BEFORE THE OHIO POWER SITING BOARD

In the Matter of the Application of)	
Kingwood Solar I LLC for a Certificate)	Case No. 21-0117-EL-BGN
of Environmental Compatibility and)	
Public Need)

NOTICE OF RESPONSES TO SECOND SET OF DATA REQUESTS FROM THE STAFF OF THE OHIO POWER SITING BOARD

KINGWOOD SOLAR'S JUNE 8, 2021 RESPONSES TO STAFF'S JUNE 1 AND JUNE 3 DATA REQUESTS

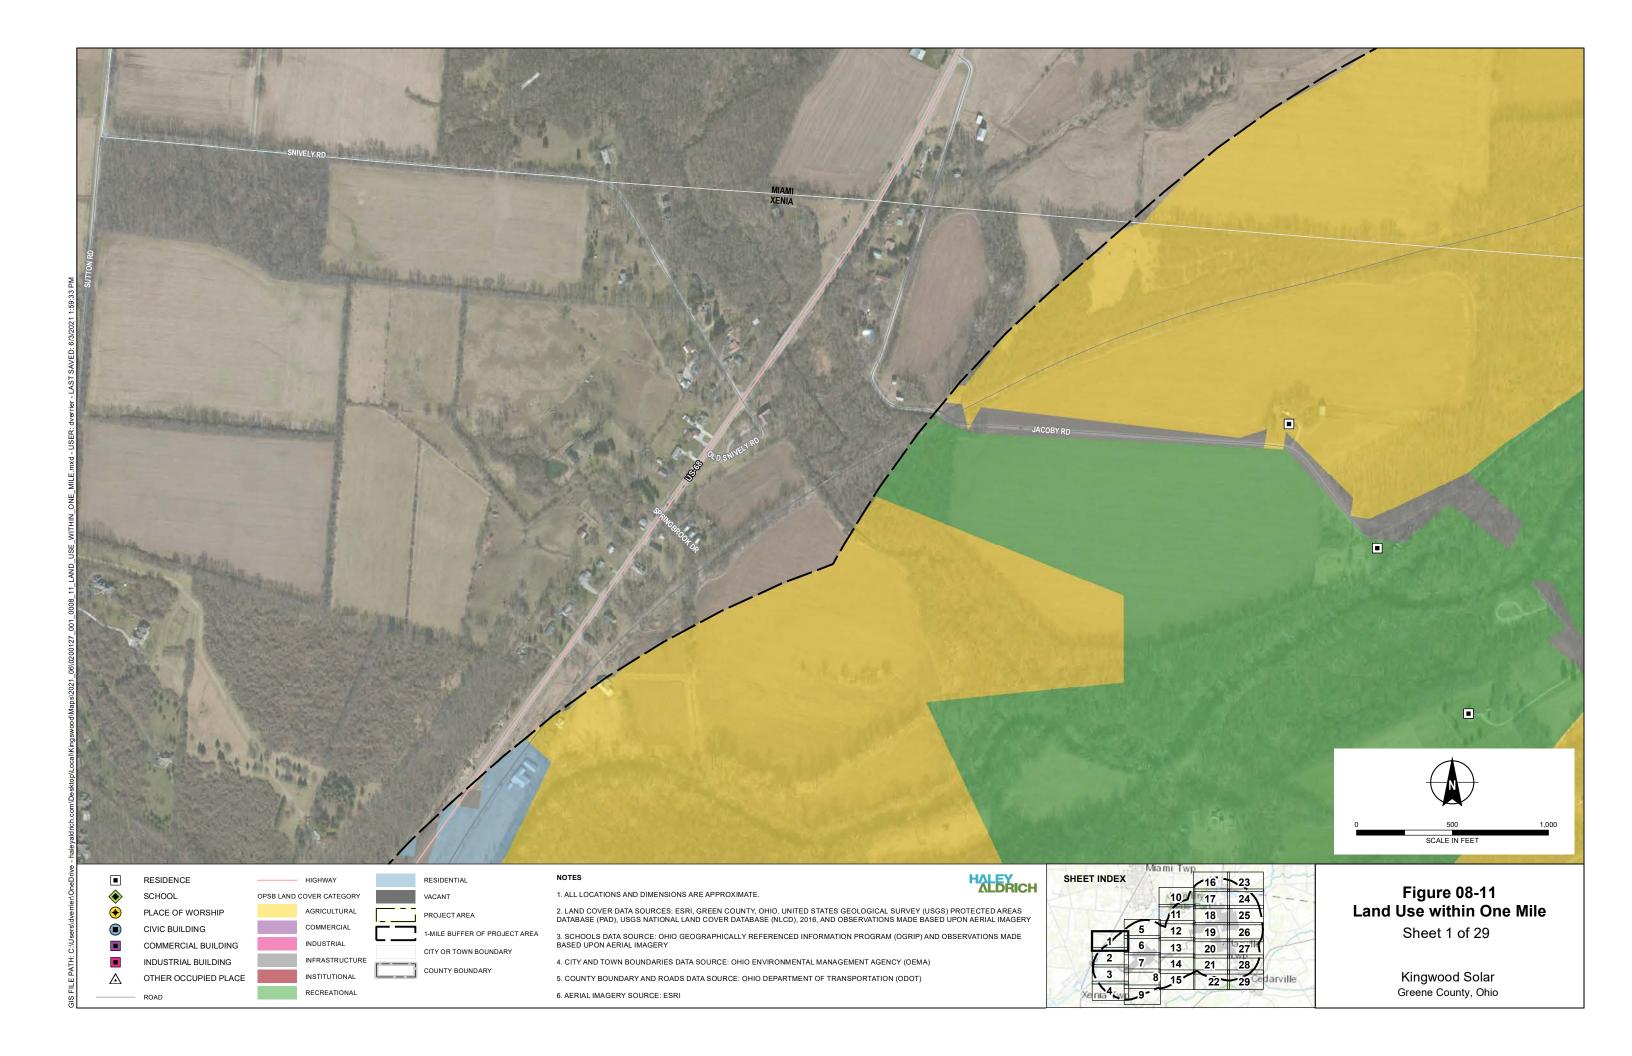
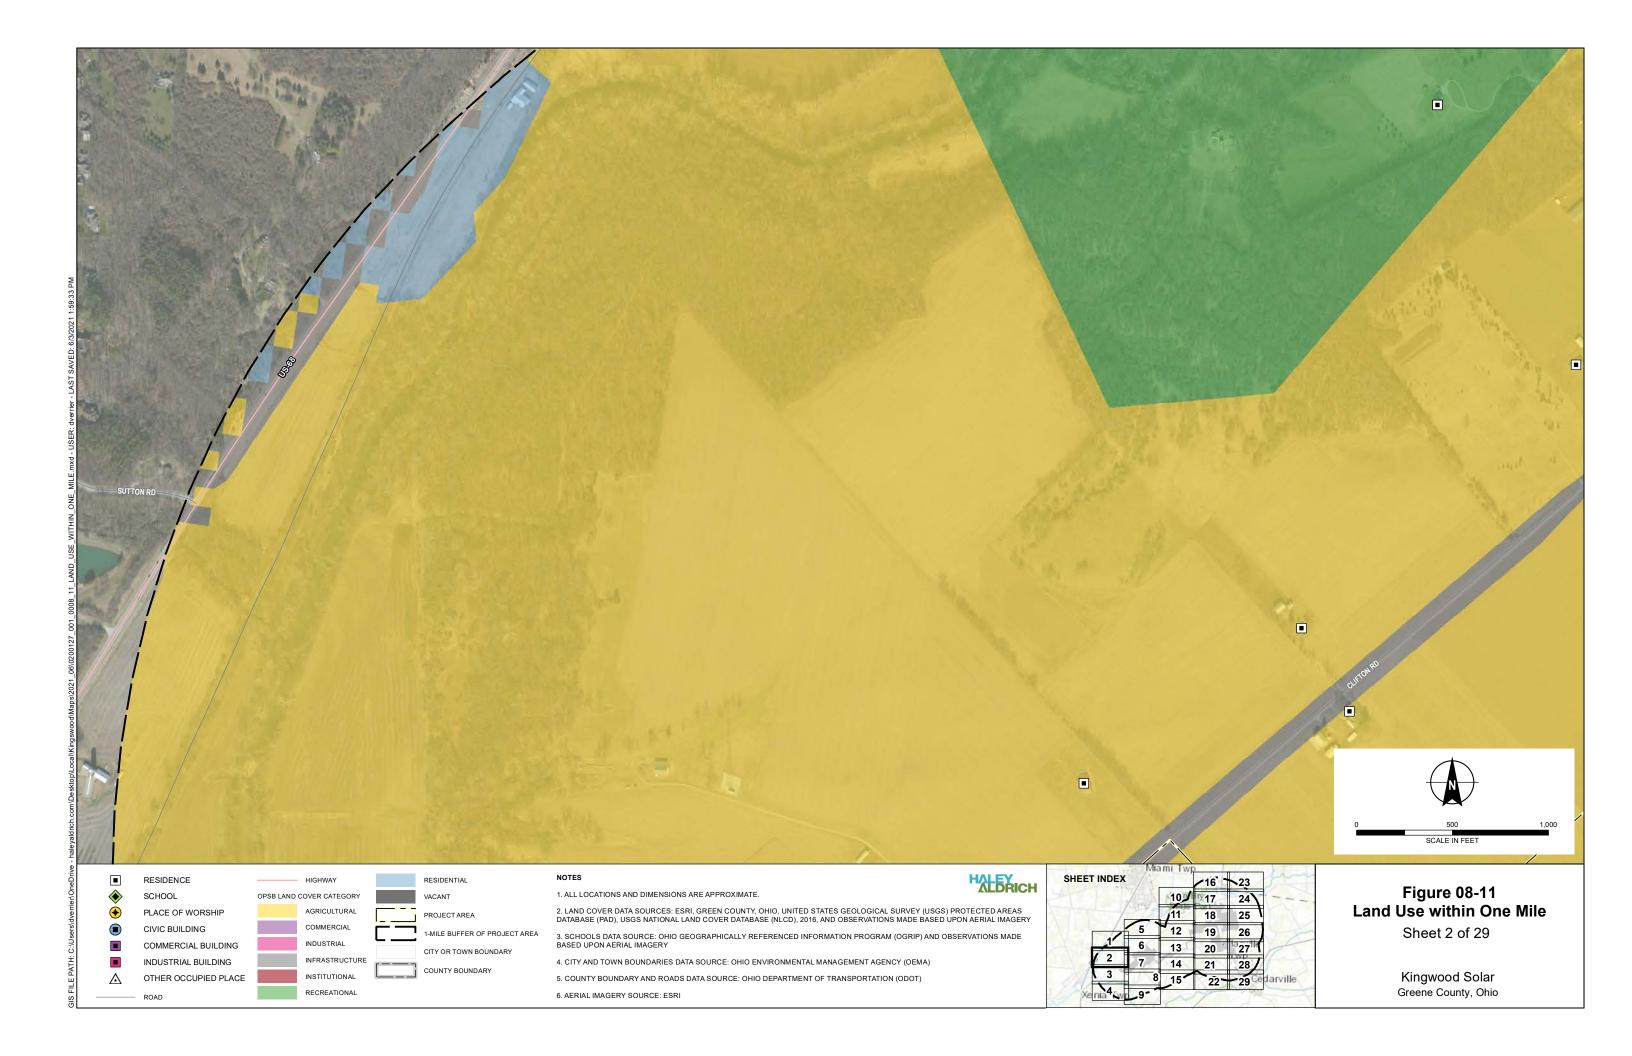
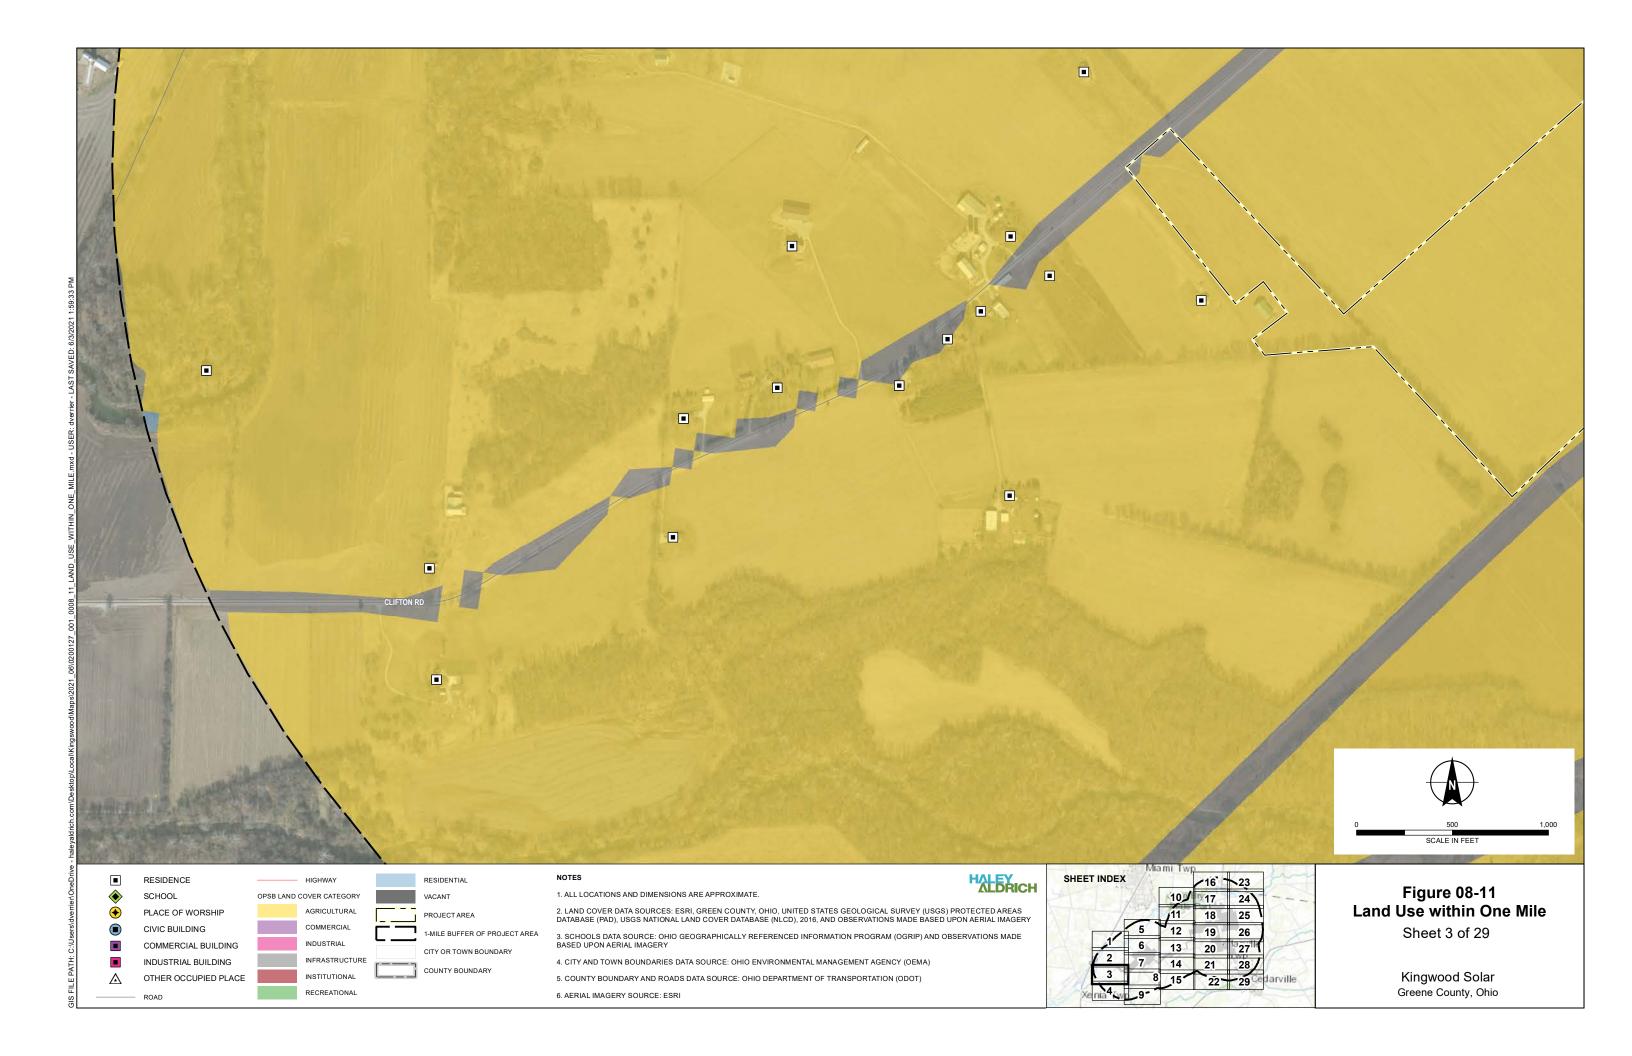
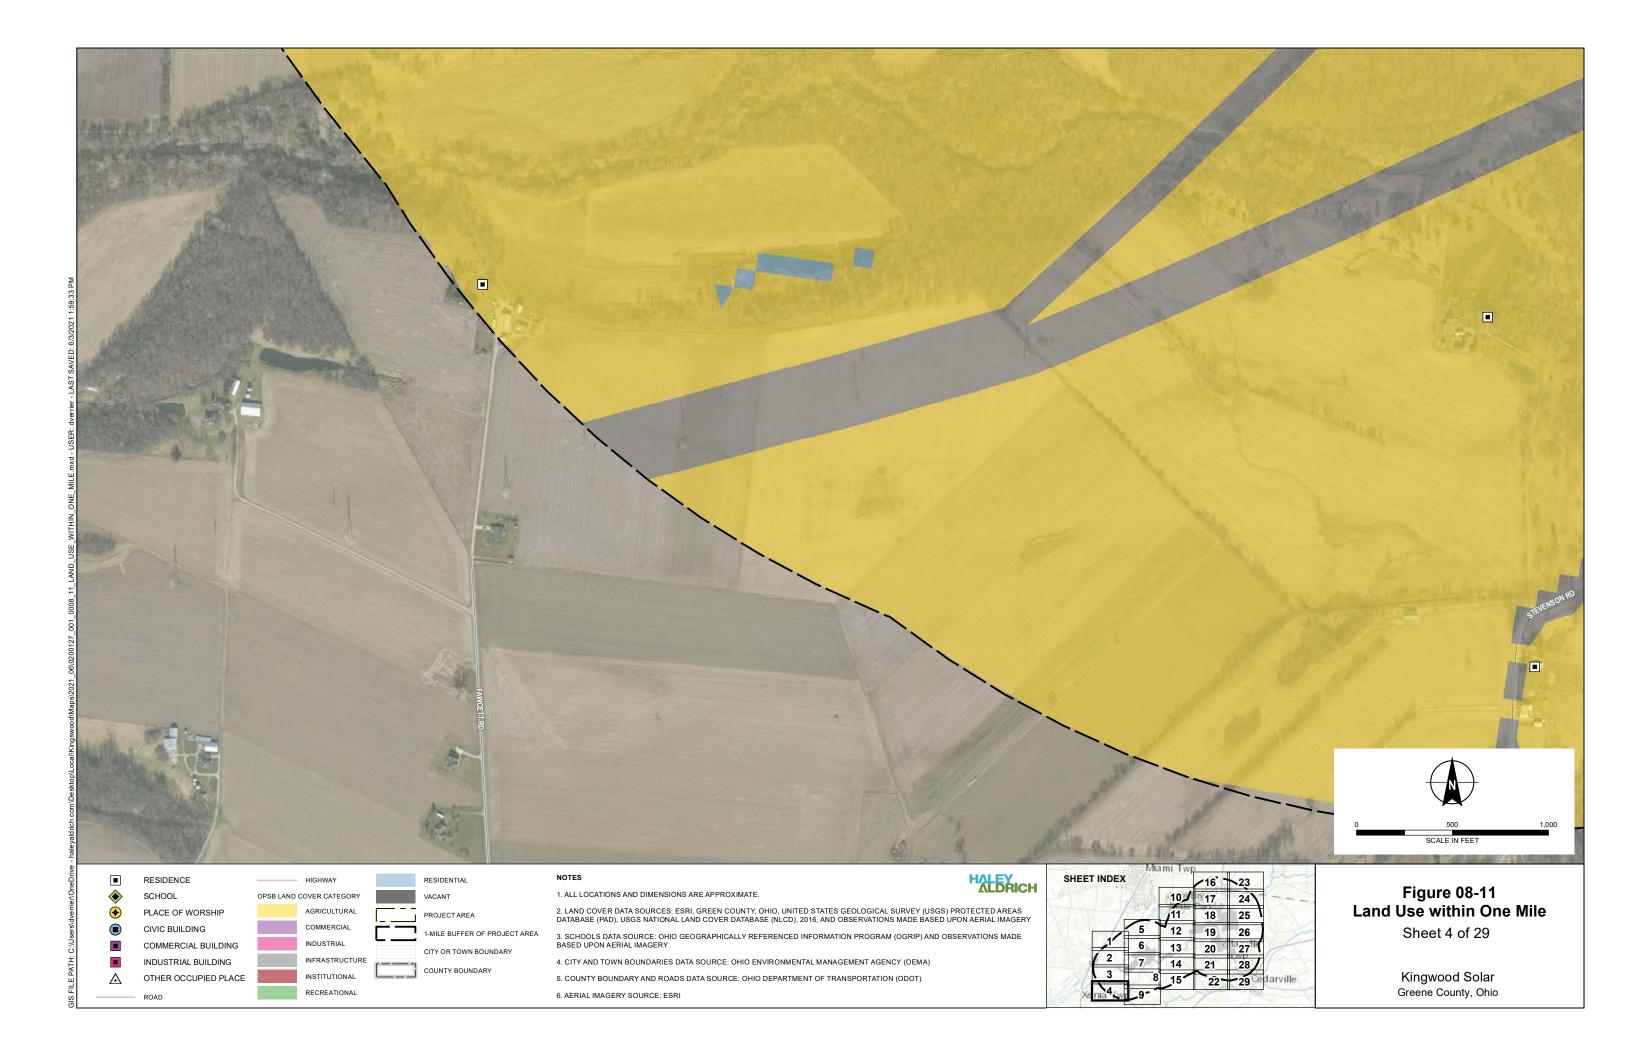
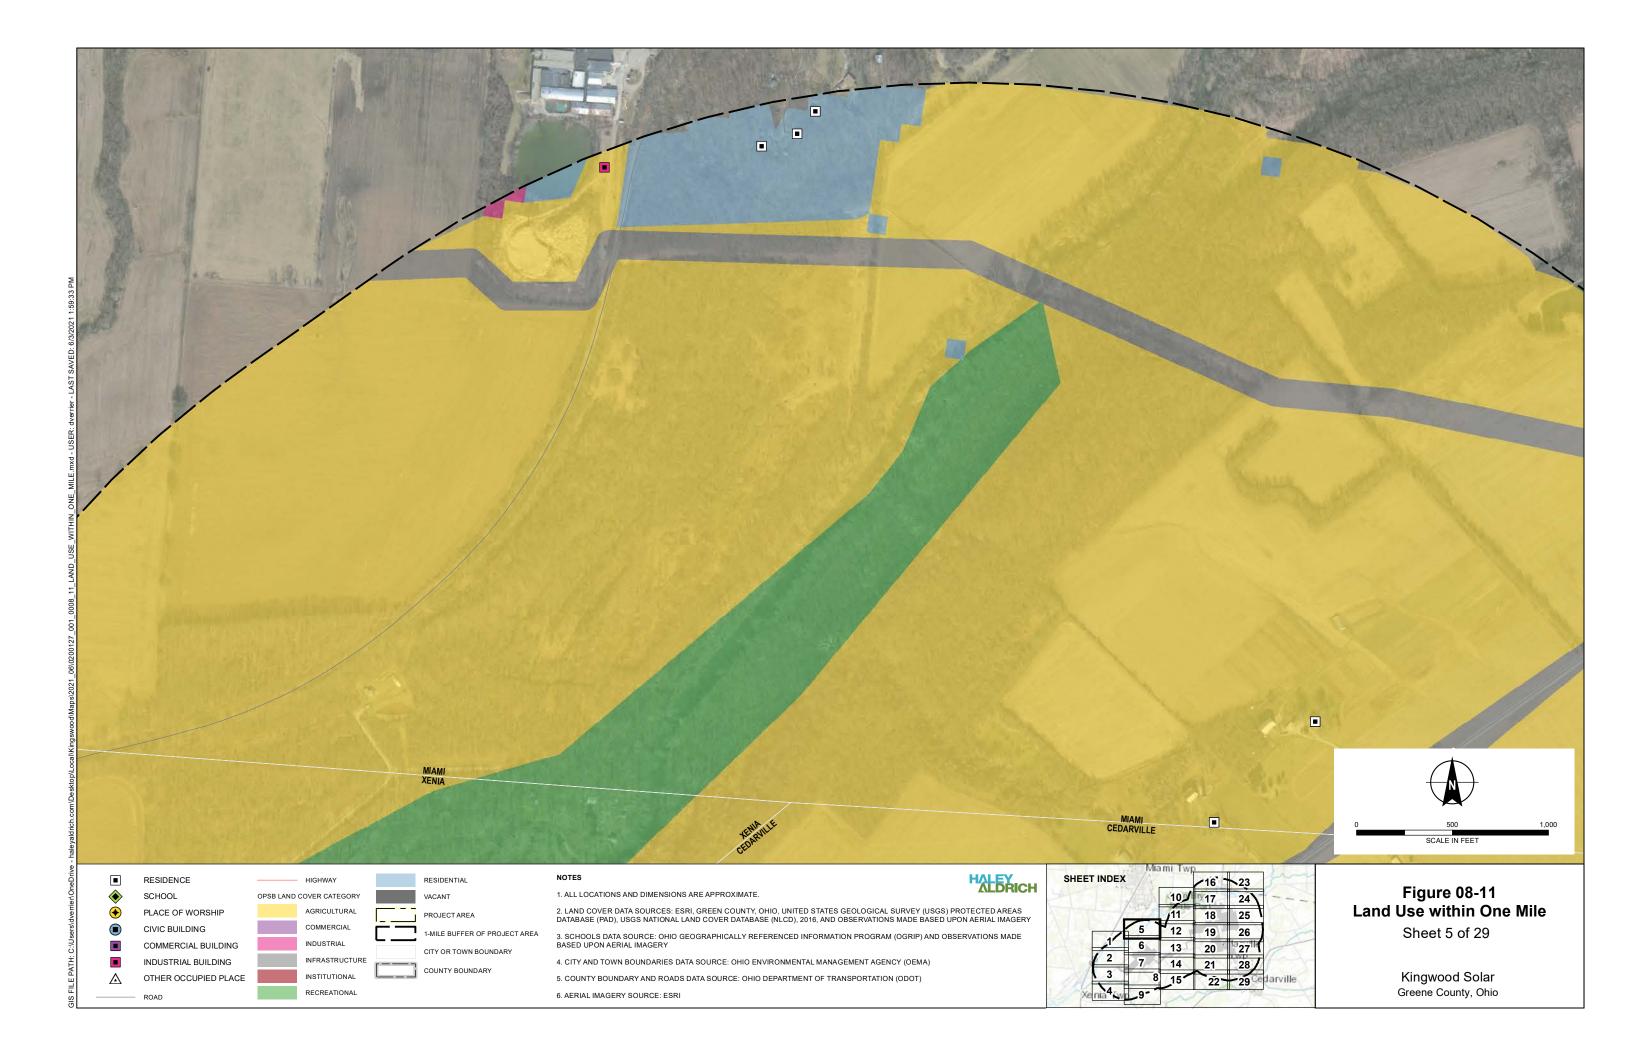
1. Figure 8-11 currently only delineates schools and residences. Amend Figure 8-11 to include the following structures depicted as points on the map, as per 4906-4-08(C)(1)(a): "...commercial centers or buildings, industrial buildings and installations,...hospitals, churches, civic buildings, and other occupied places".

A revised version of Figure 08-11 is attached that provides points on the maps for the requested features.
